PROJECT	Dendrons
---------	----------

QUESTIONS FOR THE ENGINEER

Structural queries on the ICF approval drawings - sheet 2 of 4

UKPCS-003-EQ-01

EQ-01 SF-S06 / SF-S08 bearings over the FF windows FF-WF02 / FF-WF19 (S-102, S-121)

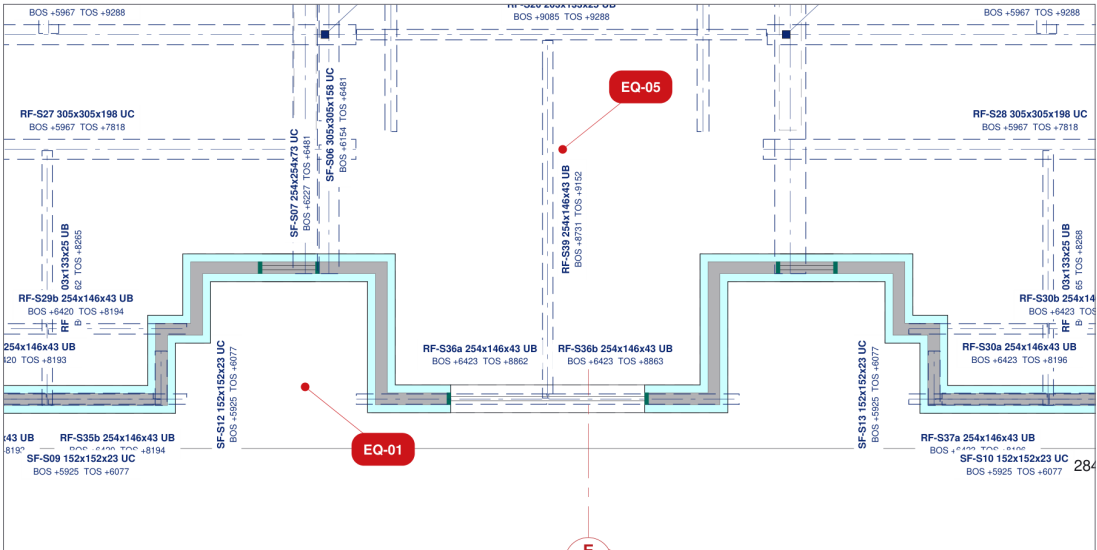
ISSUE The second-floor transfer beams SF-S06 (UC 305x305x158, x 6370) and SF-S08 (UC 356x406x287, x 12586) bear on the south wall (L2, top 174.975 AOD) directly over the 685-wide FF windows either side of the entrance bay. At TOS 175.229 the beam undersides are 6252 (S06) and 6185 (S08) above the slab datum; the architect's window head is 6023, leaving 229 mm (S06) and 162 mm (S08) of wall between head and beam. S-121 schedules an RCB152 x 300 - 2H16 lintel there, which would reach 6323, 71 mm into SF-S06 and 138 mm into SF-S08.

QUESTION Please confirm the bearing detail: a steel spreader under each beam end (model assumption UC 152x152x30, 1285 long, 300 bearing each side, TOS = beam underside), or a revised lintel / beam arrangement. The window positions are the architect's and are held.

EQ-03

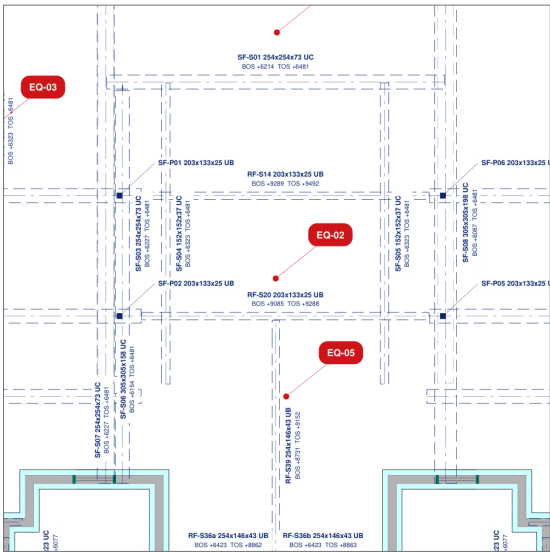
QUESTION Please confirm its purpose and bearings (lift overrun trimmer?).

QUESTION Please confirm the intended TOS of the cranked frames and knee beams, and the splice arrangement of the collinear plateau pairs.

EQ-05 RF-S40 / RF-S41 bay ridge beams land 244 mm above RF-S27 / RF-S28

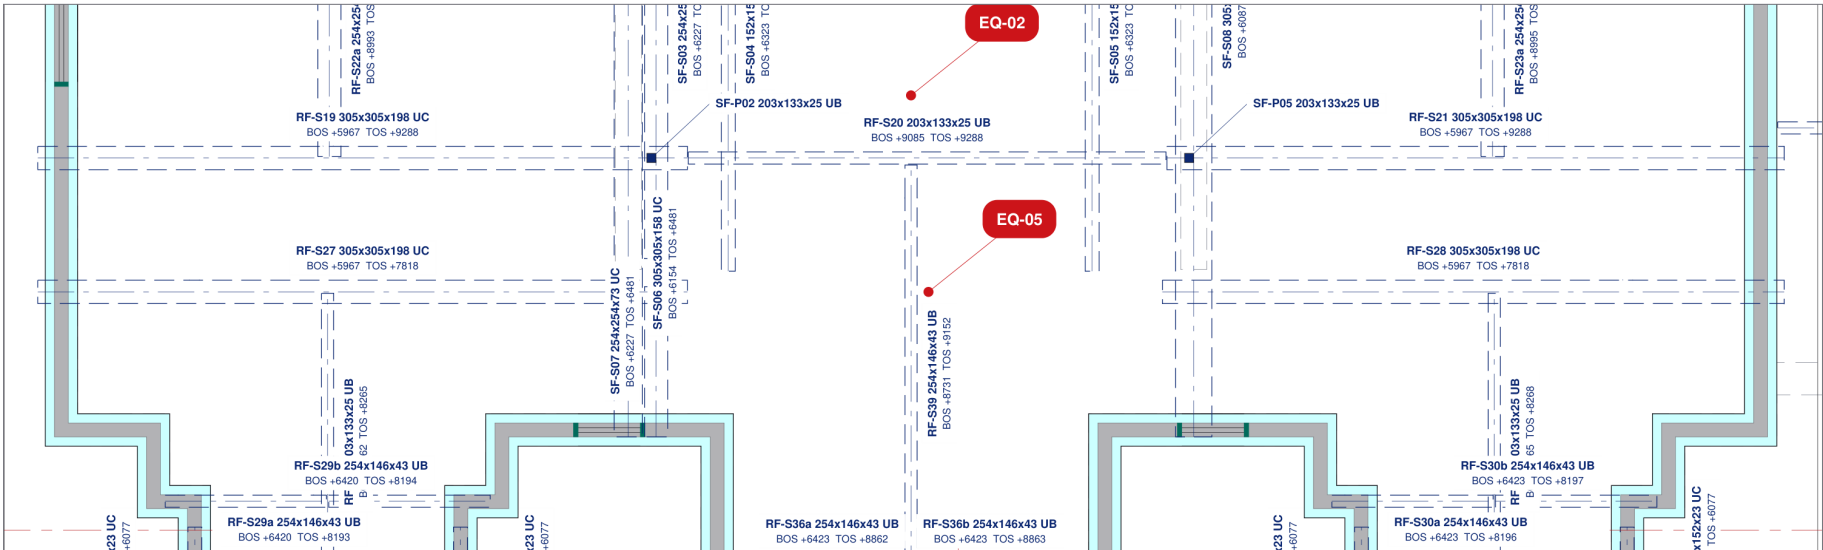
ISSUE RF-S40/RF-S41 (bay 1/3 ridge beams, TOS 177.013) land 244 mm above RF-S27/RF-S28 (TOS 176.566); modelled on 244-high stools.

QUESTION Please confirm the stool / seating detail.
